Addendum No. 1

Date: September 17, 2025
Invitation to Bid: 25-2866-8JL – Henrico County Animal Shelter Renovation
Receipt Date/Time: September 23, 2025 at 2:00 PM
Opening Date/Time: September 23, 2025 at 2:00 PM
Subject: Questions & Answers Modifications to the Project Manual, and
Modifications to the Drawings

DEMOLITION FIRST FLOOR PLAN
 A1.2.1 A1.2.1 1/8" = 1'-0"

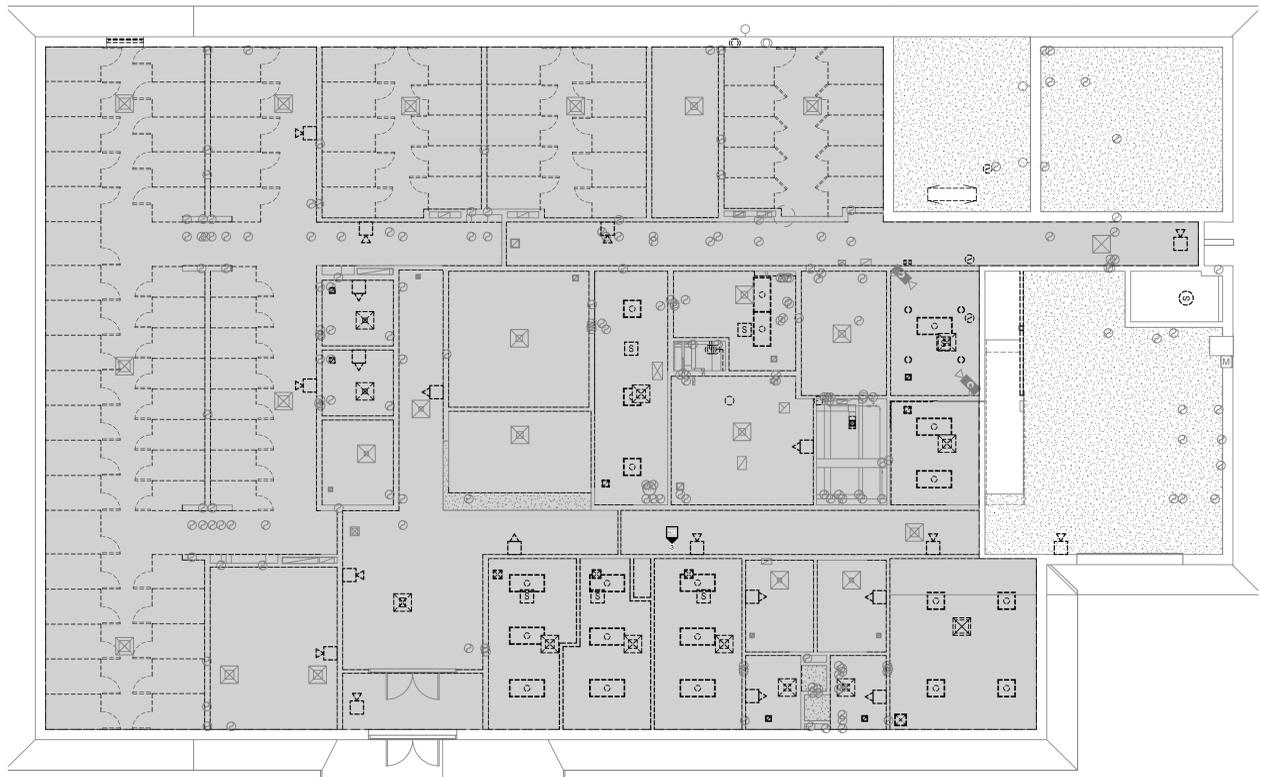
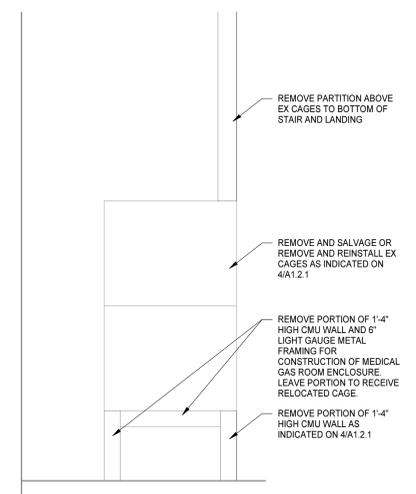
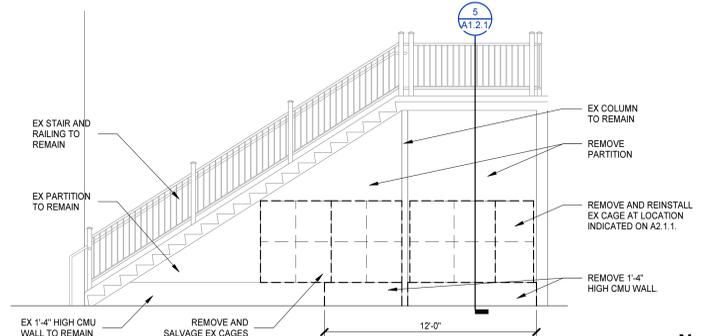
15. Question: Detail 4/A1.2.1 – There is a note indicating the Existing cages are to be removed and salvaged. The Dual cage gets re-installed per Note 5 on A2.1.1 Are the Quad cages (3ea) being returned to owner or installed elsewhere?

18. Question: Sheet A1.2.1 – Selective Demolition Notes 3,4,7,8, & 11, 17 indicate removing owner items. Are these to be returned to owner or to be disposed?

19. Question: Sheet A1.2.1 – Selective Demolition Note 17 indicates the removal of existing door with existing frame to remain. Is there any additional work to finish out existing frame (filling / capping existing hardware mounting locations, etc.) for any desired finish?

20. Question: Sheet A1.2.1 - Are any of the existing doors that are to be removed per plan to be returned to owner?

23. Question: Sheet A1.2.1 – Room #109. Is the existing Dishwasher (DW) to remain and be re-utilized?

Answer: [Refer to specification section 024100 Demolition for clarification on “Remove and Salvage” terminology.](#)

[Answer: Remove as directed in specification section 024100 Demolition.](#)

[Answer: Refer to additional keynote on A2.1.1.](#)

[Answer: Remove as directed in specification section 024100 Demolition.](#)

[Answer: Refer to additional demolition keynote 18.](#)

FLOOR PLAN
 1/8" = 1'-0"

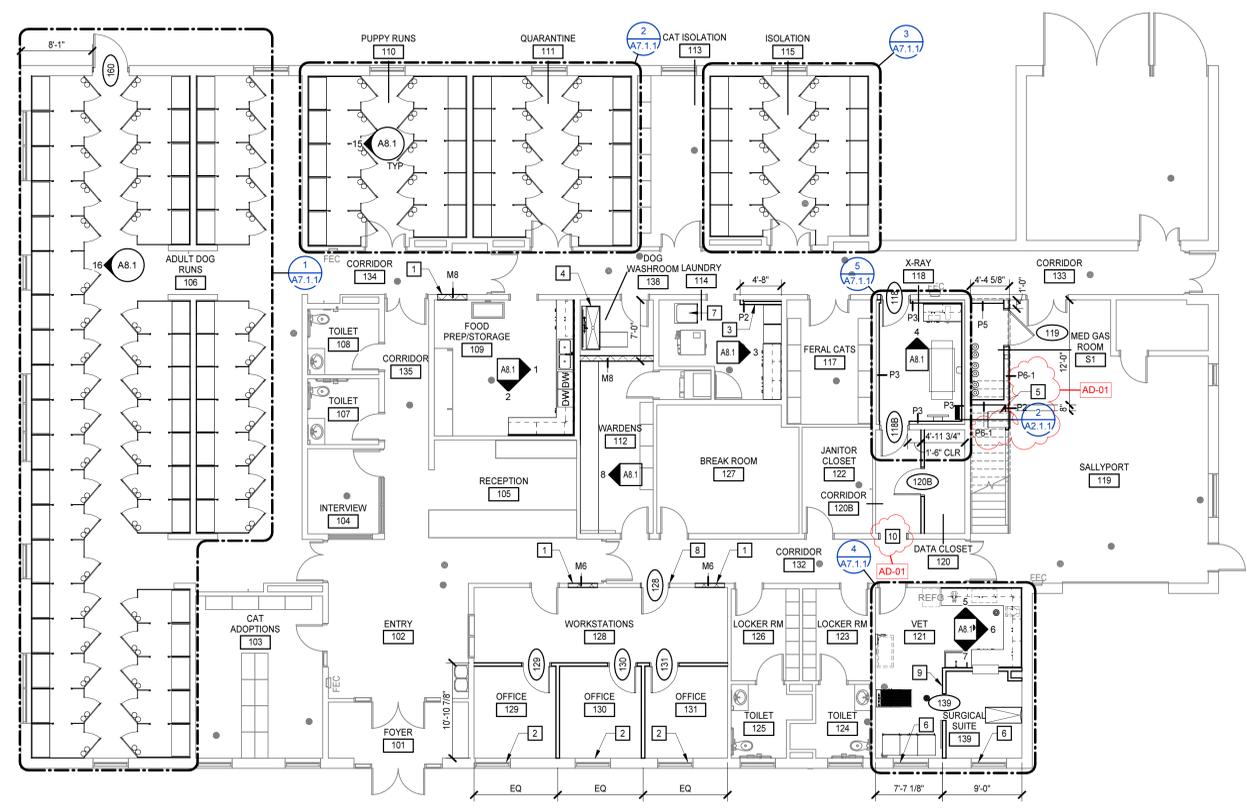
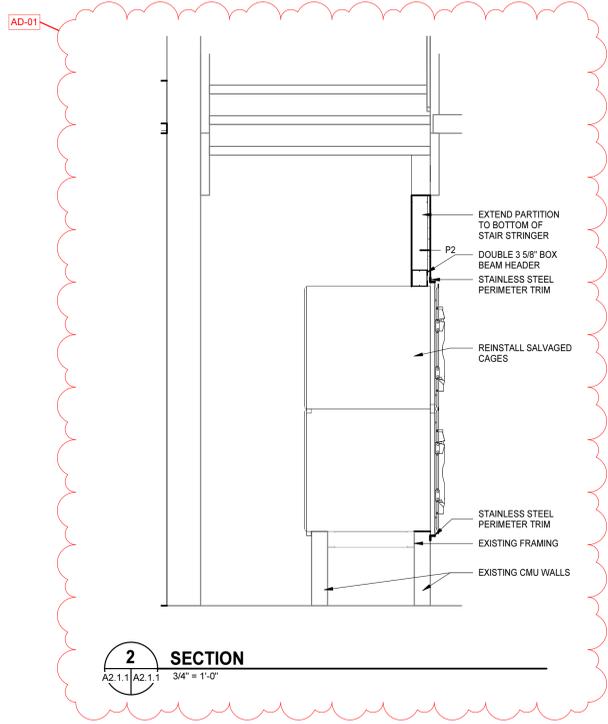
5. Question: A9.1.1 calls out partitions to extend up to the rated horizontal shaft wall, however, drawing A2.1.1 shows partitions type P 1.1. P1.1 is not shown as a fire rated partition per A0.2. Please clarify.

16. Question: Note 5 on Sheet A2.1.1 indicates the re-installation of the salvaged Dual cage. Please provide framing and dimensional information for the new location. Please provide clarity on the stainless-steel angle closure indicated for complete installation.

[Answer: Refer to revised partition tags on A2.1.1 revised.](#)

Answer: [Refer to additional detail on A2.1.1.](#)

1 INTERIOR FINISH PLAN
 A4.1.1/A3.0.1 1/8" = 1'-0"

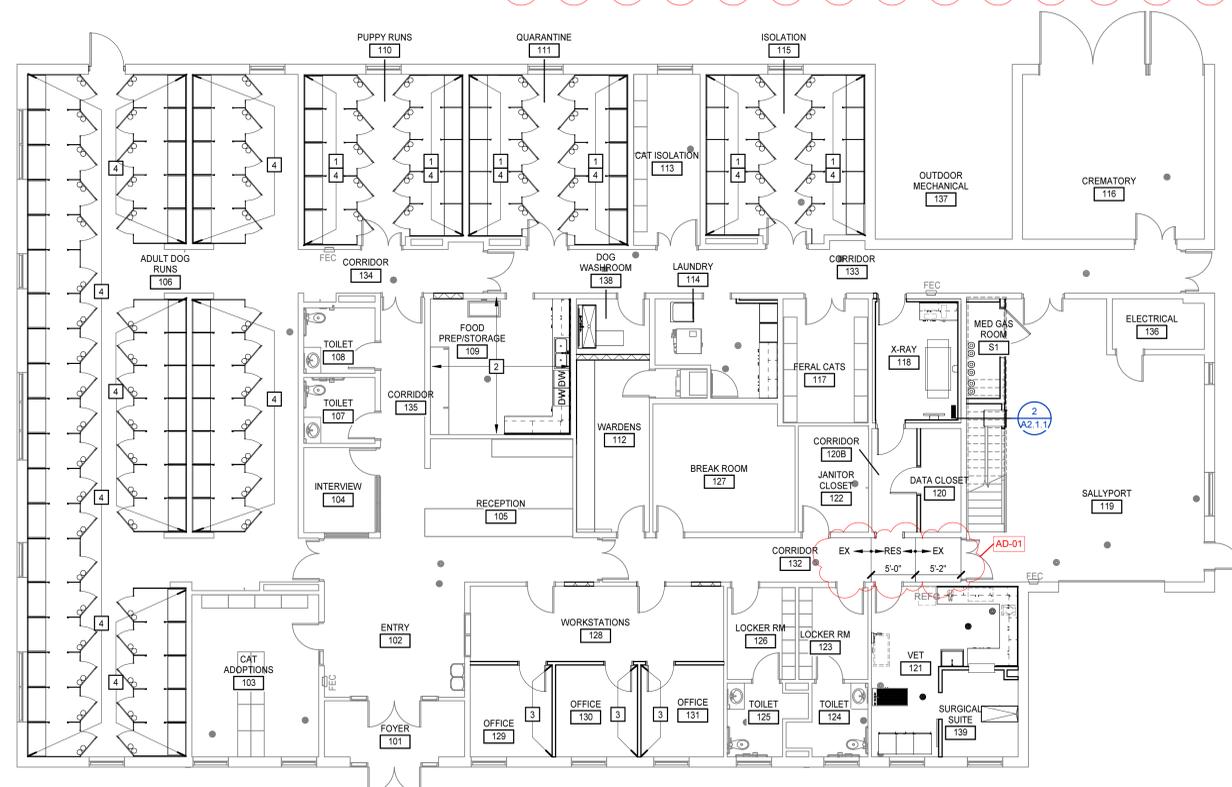
3. Question: The finish plan shows several rooms where the existing floor is to remain and new epoxy is to be installed. There is no clear determination of the amount of the existing flooring that will remain and the extent of the new flooring. Please clarify?

7. Question: Are the ACT ceilings (Grid and Tile) to be replaced in its entirety? The demo plan sheet A1.2.1 shows the entire ceiling being demolished. Finish Schedule sheet A3.0.1 has numerous rooms listed as existing.

8. Question: There are numerous rooms missing from the finish schedule. If the rooms not listed on the finish schedule do need new ACT I will need to know if I should price ACP-A or ACP-B. (rooms missing from schedule – 101, 102, 103, 104, 105, 113, 117, 123, 126, 127)

25. Question: Sheet A1.2.1 – Room 138 indicates the removal of existing ceiling for above scopes of work. Sheet A9.1.1 appears to indicate new GWB Ceilings to be installed. The Finish Schedule on Sheet A3.0.1 indicates an existing ceiling condition. Please clarify.

[Answer: Refer to revised finish schedule on A3.0.1.](#)

[Answer: Refer to revised finish schedule sheet A3.0.1.](#)

[Answer: Refer to revised finish schedule sheet A3.0.1.](#)

[Answer: Refer to revised finish schedule sheet A3.0.1.](#)

STEEL FRAME SECTIONS
NO SCALE

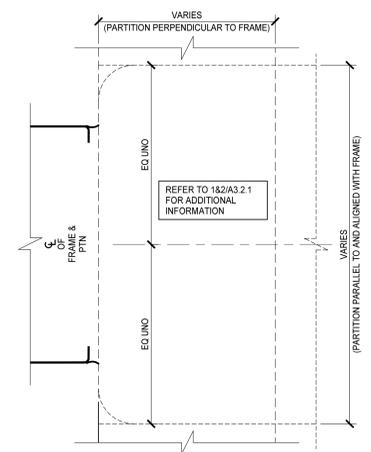
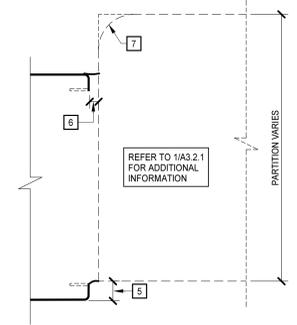
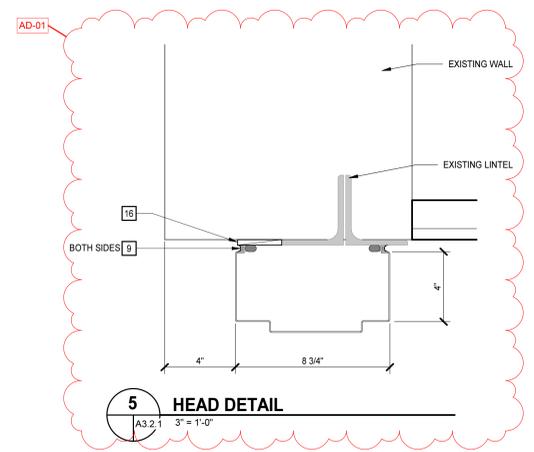
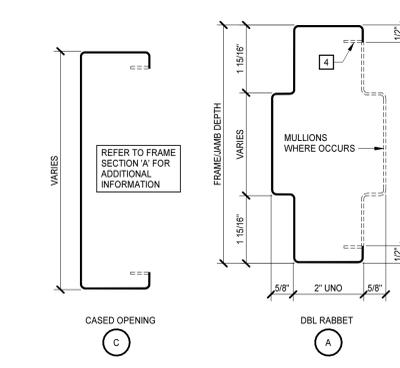
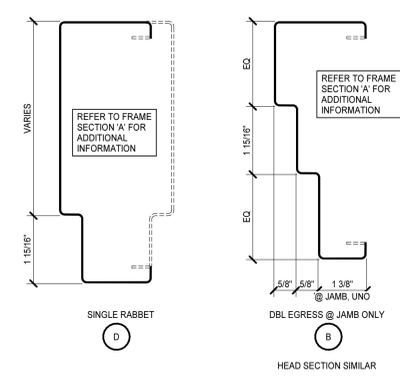
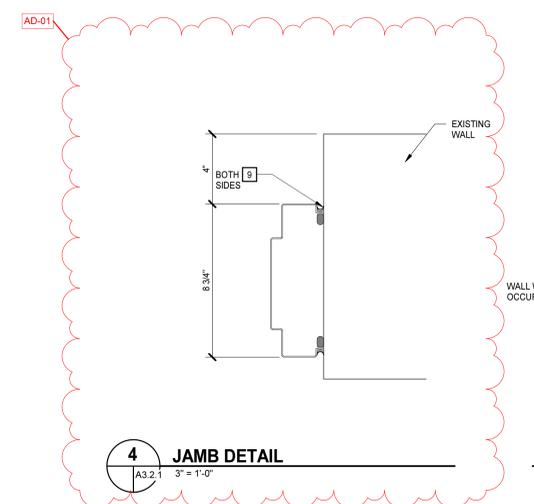
24. Question: Sheet A3.2.1 – Please clarify any associative materials (any blocking, flashing, weather proofing, steel lintels, etc.) for desired Exterior Door frame installation (Door #160). Current conditions are block along sides and wood framing along head. Also given the current conditions, grout filling header of frame will be improbable. Please advise / Clarify.

[Answer: Refer to revised details on A3.2.1.](#)

APPLIES TO DRAWINGS A9.1.1
 REFER TO M, E & FP DRAWINGS FOR REFLECTED CEILING PLAN SYMBOLS NOT INDICATED BELOW

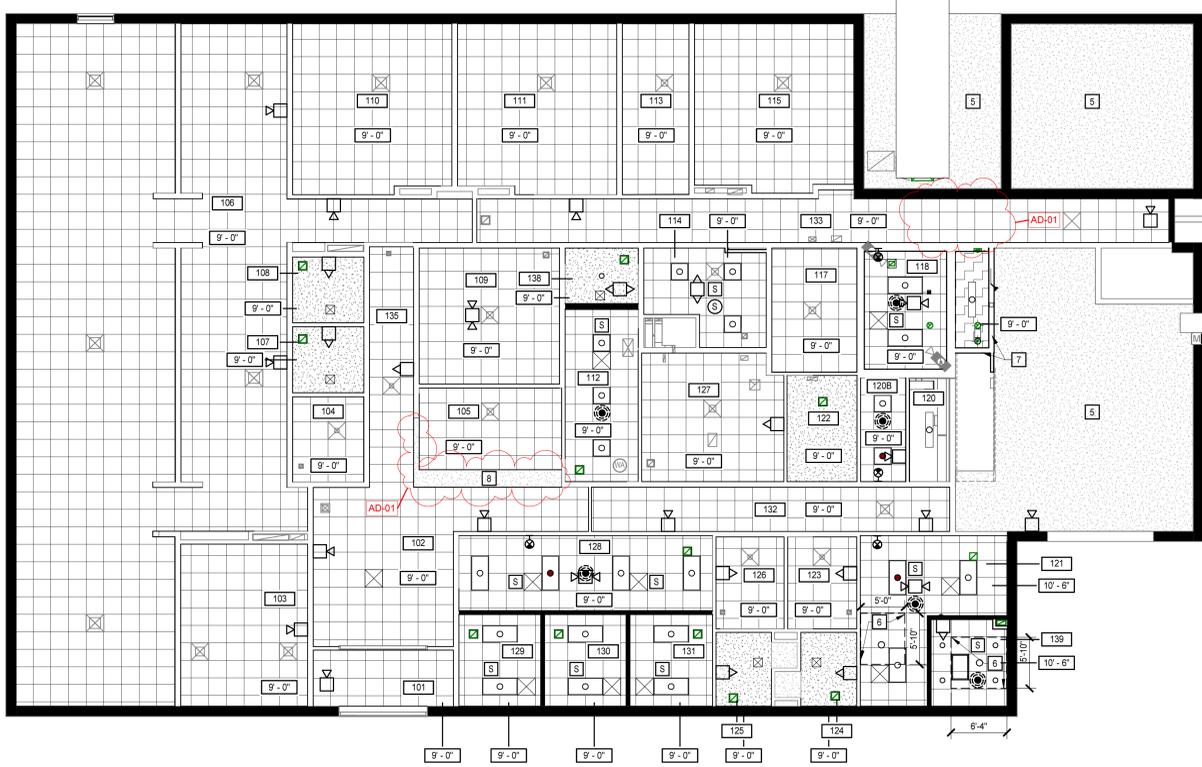
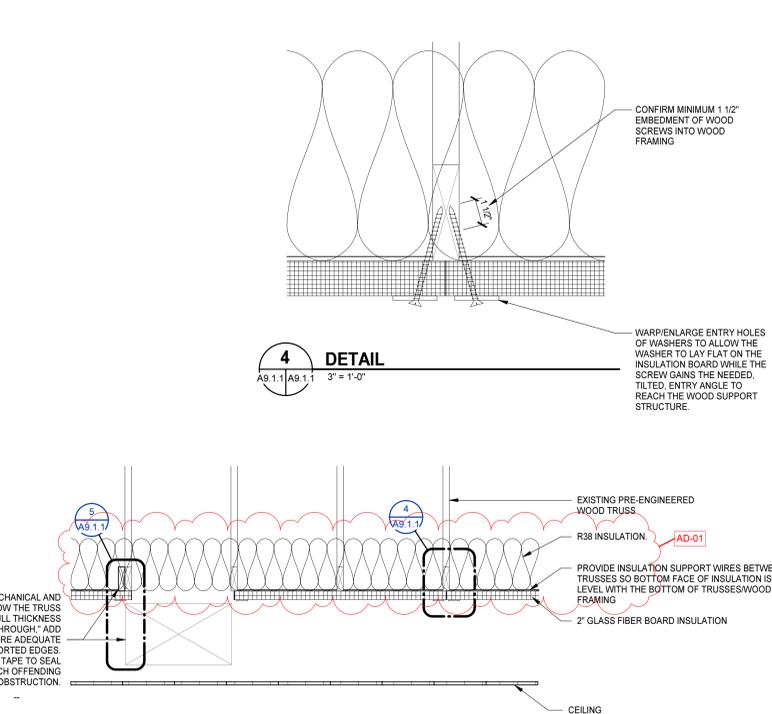
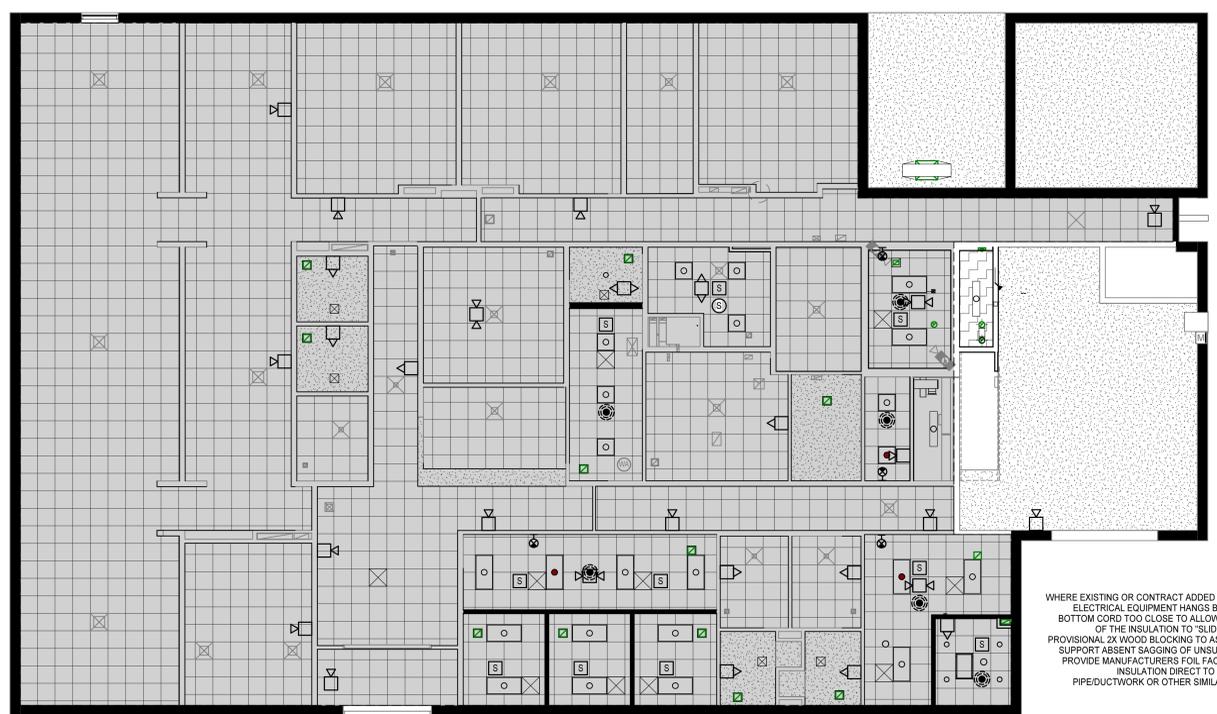
26. Question: Sheet A9.1.1 – Room 105 / 102. Does the assumed GWB markings in this lobby / reception area indicate a new or existing bulkhead assembly for this location? Please clarify.

[Answer: Refer to revised annotations on A1.2.1 and A9.1.1.](#)
